Addendum No. 1

RE: Contract # C205086

Jackson County (R-5600)

US-23 BUSINESS AT MILL ST, TO NC-107, ALONG NC-107 (E MAIN ST) TO
SOUTH OF SR-1780 (LOVEDALE RD)

PROJECT REFERENCE NO.	SHEET NO.
R-5600	2C-16

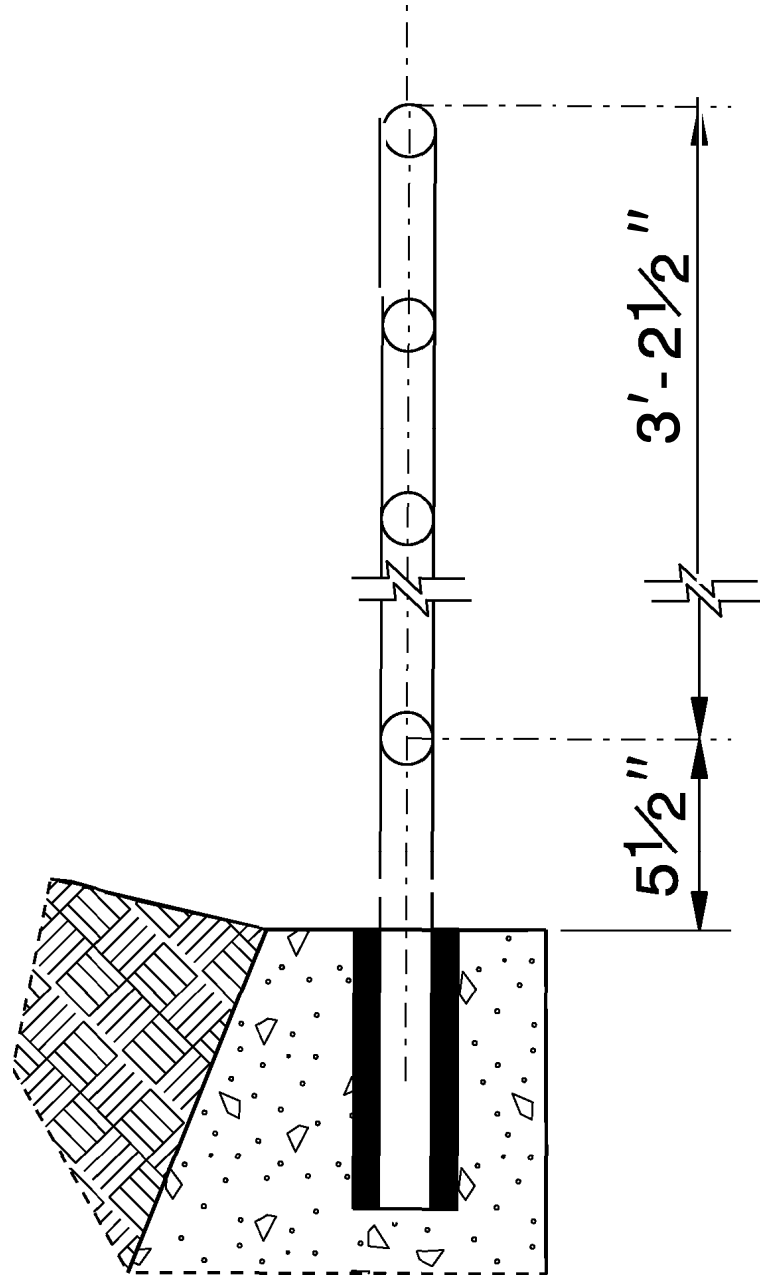
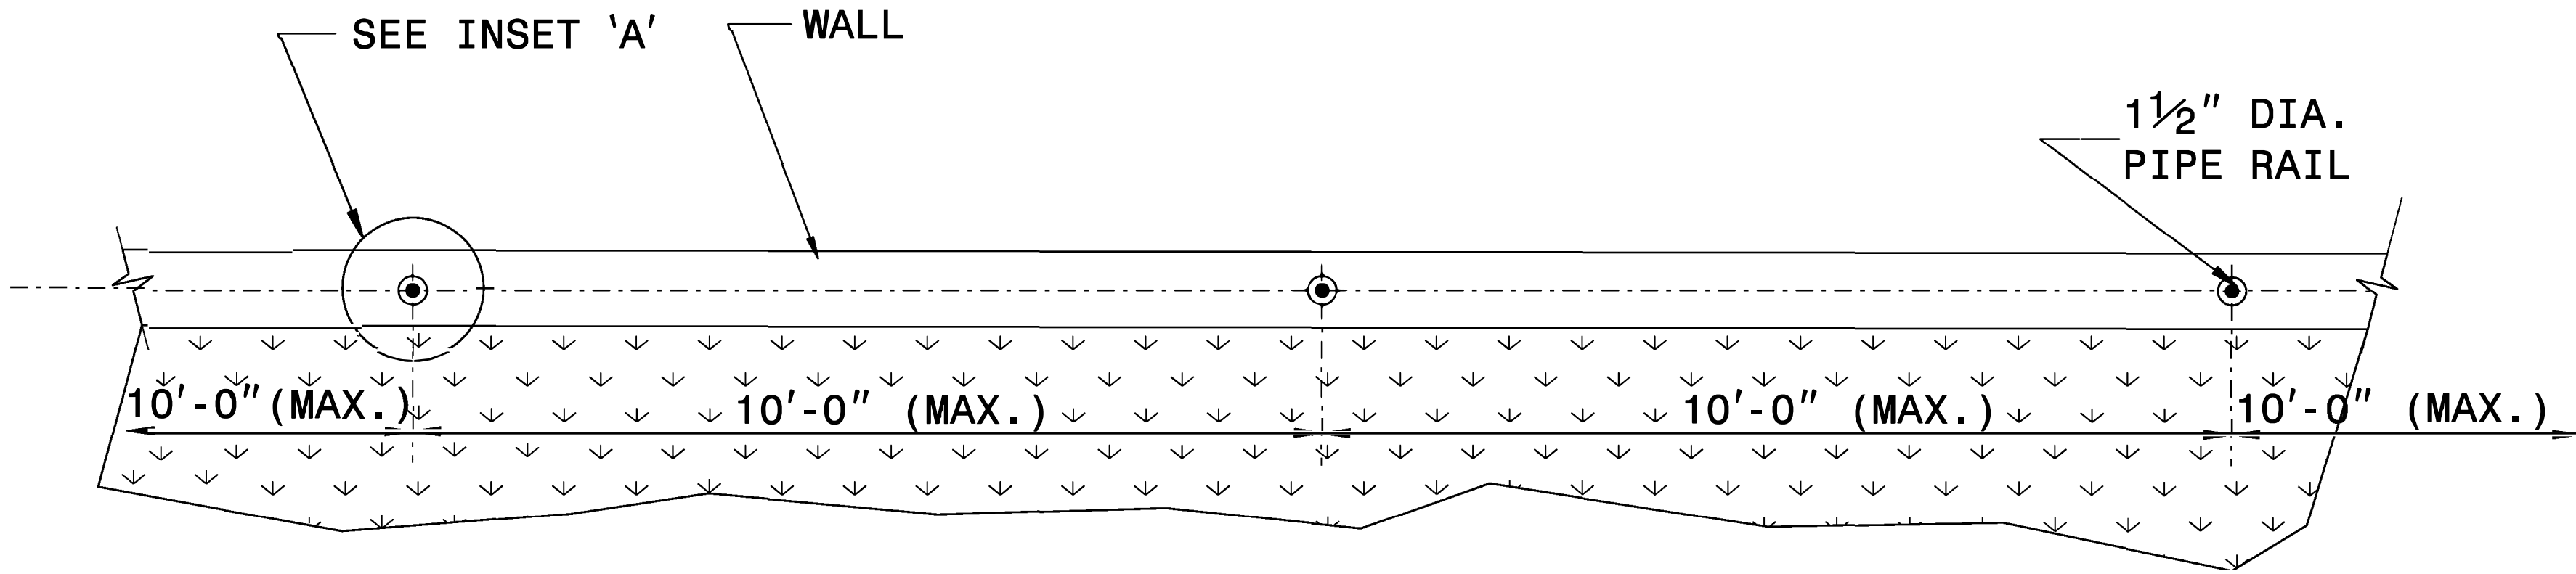
Sheet No.	Revision
2C-16 & 2C-17	NOTES have been revised to delete painting reference.

CONSTRUCT PROPOSED STEEL PIPE RAIL 1 1/2" DIAMETER
SCHEDULE 40 PLAIN END GALVANIZED STEEL PIPE MEETING THE
REQUIREMENTS OF ASTM A53.

WELD IN ACCORDANCE WITH ARTICLE 1072-18 OF
THE STANDARD SPECIFICATIONS.
